August 14, 2017

**RE: Lot 4 Block 6 Unit 18, S.A.D. 228
Volcano Cliffs Subdivision
6616 Kimmick Dr. NW
Grading and Drainage Plan
Engineers Stamp Date 7-27-17 (D10D00M4)**

DRAINAGE AND TRANSPORTATION INFORMATION SHEET

| CANDELARIA — GONZALES — GRADING & DRAINAGE PLAN | | | |

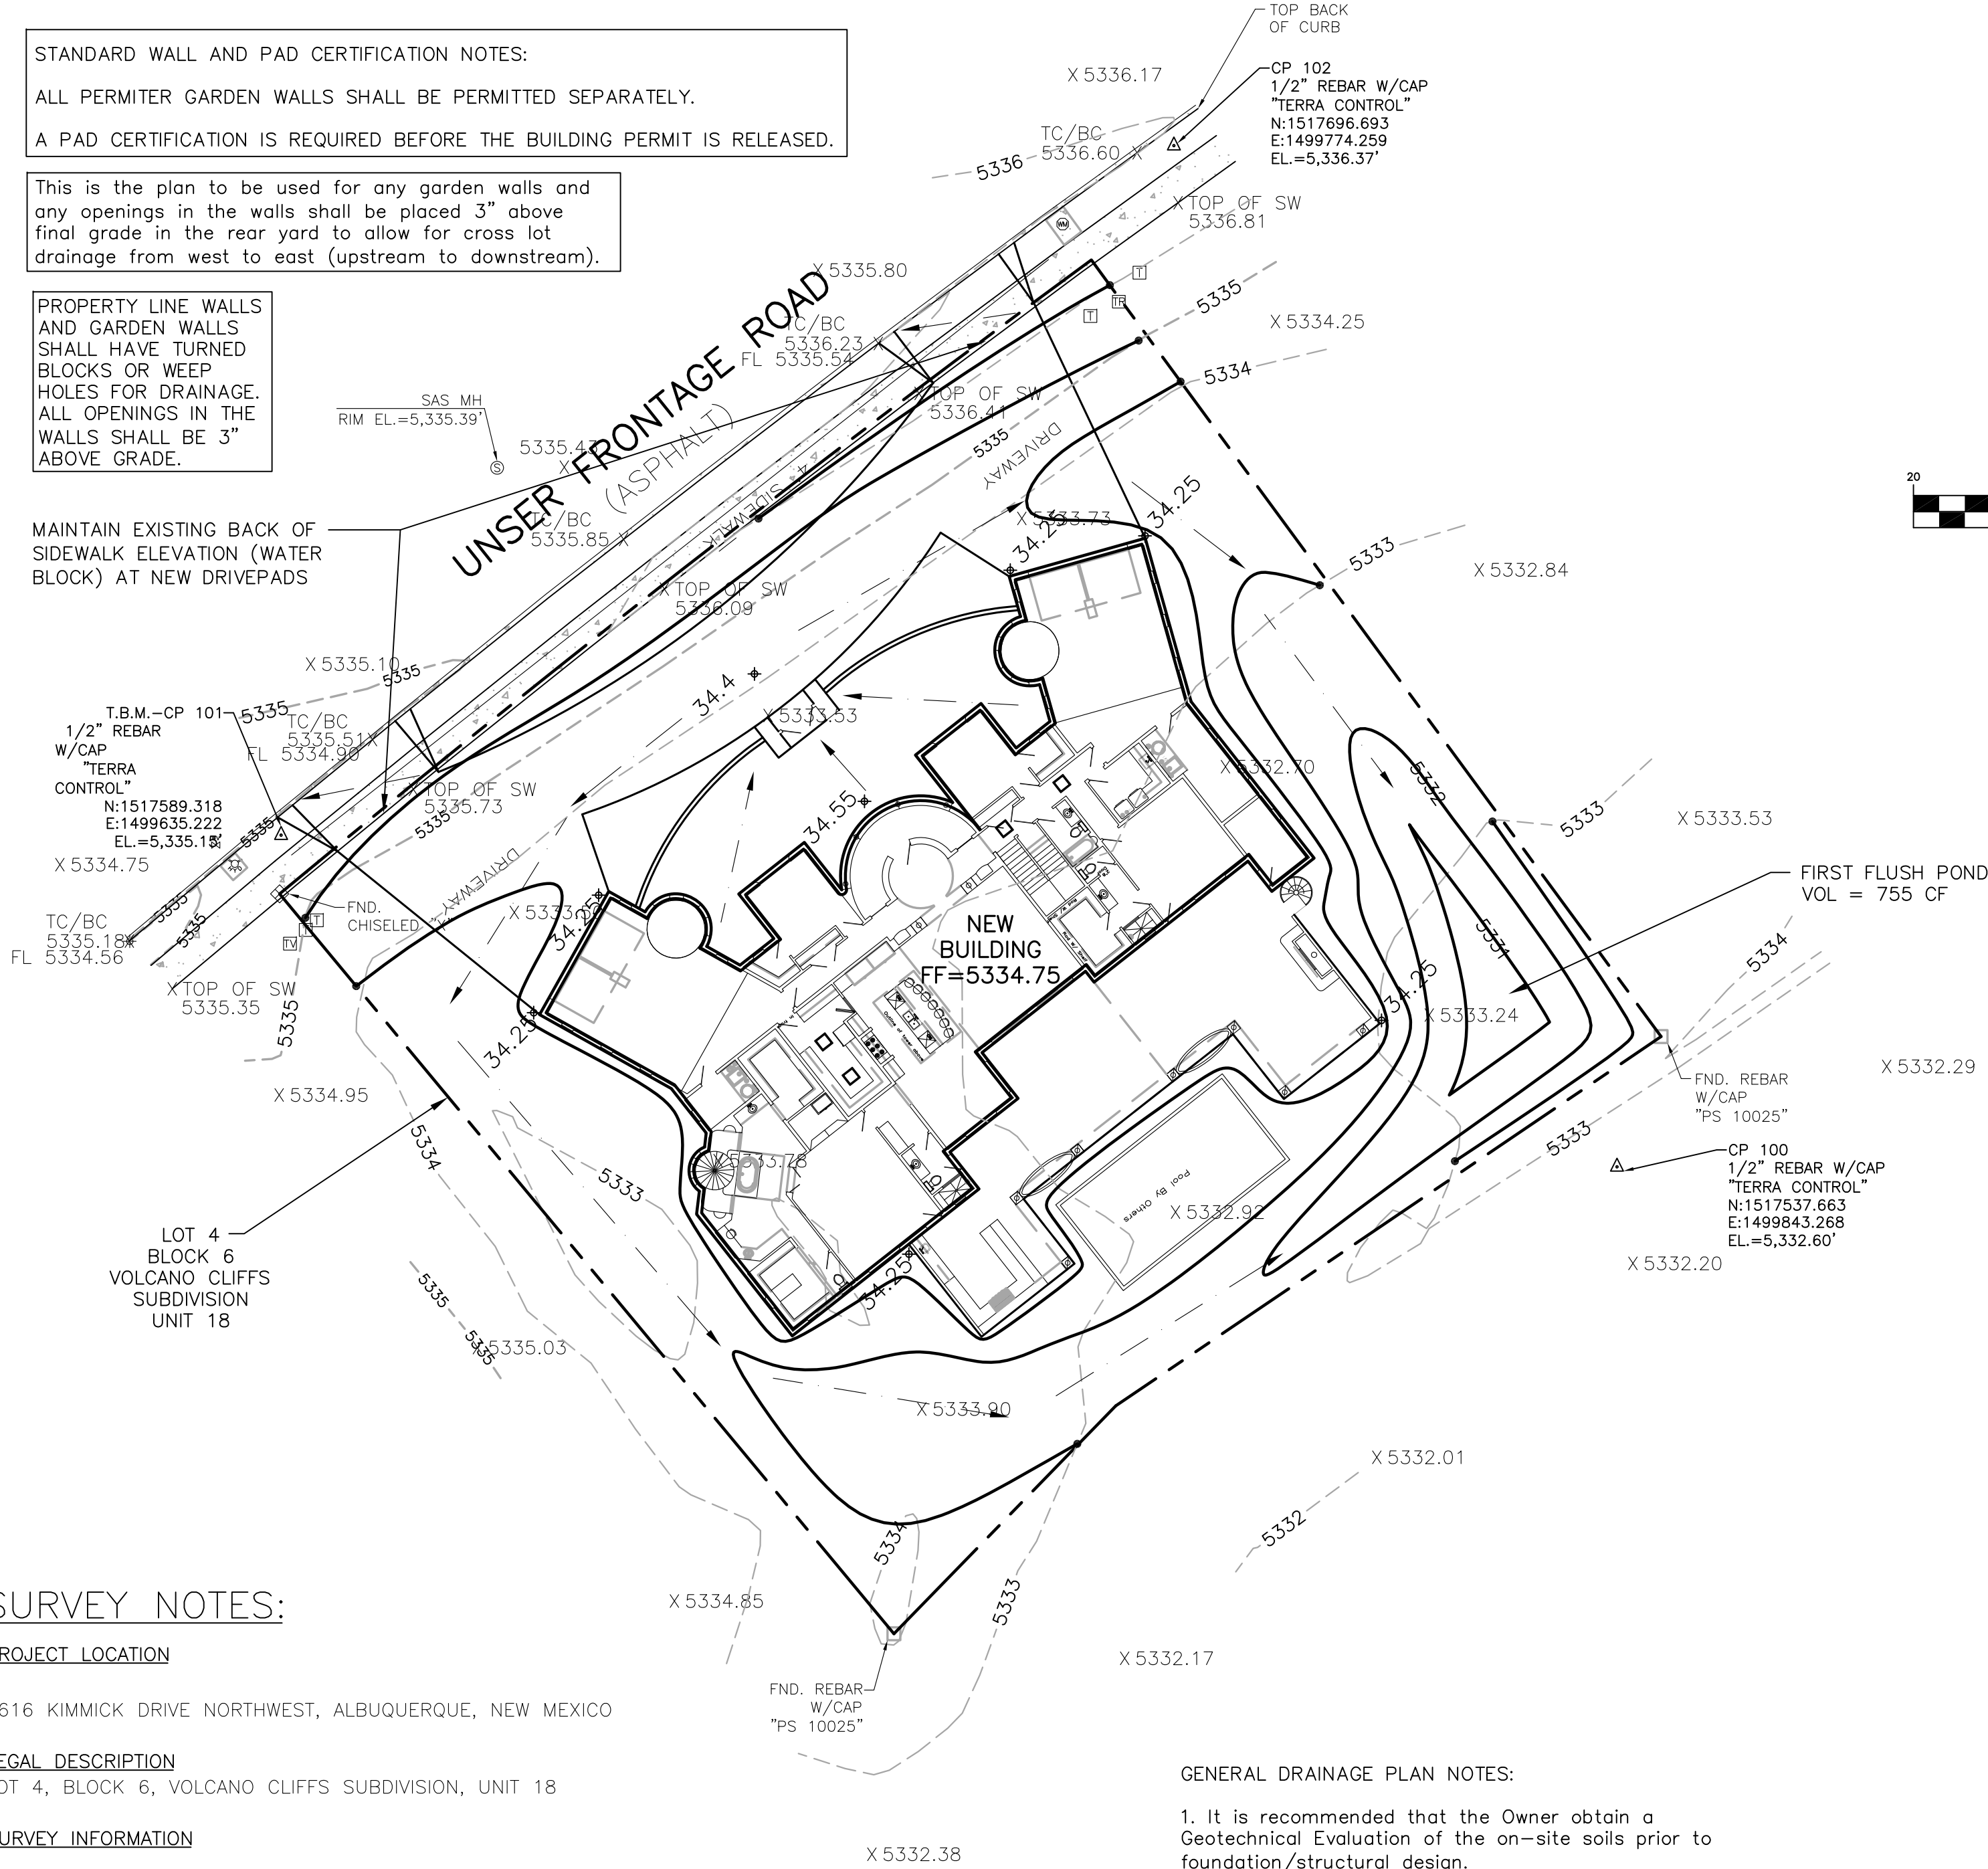
Based upon the information provided in your submittal received 7/27/17, this plan is approved for Grading Permit. Please be advised that, before the building permit can be issued a PAD Certification must be approved

Please have the owner/builder attach a copy of this approved plan, to the construction sets in the permitting process prior to sign-off by Hydrology.
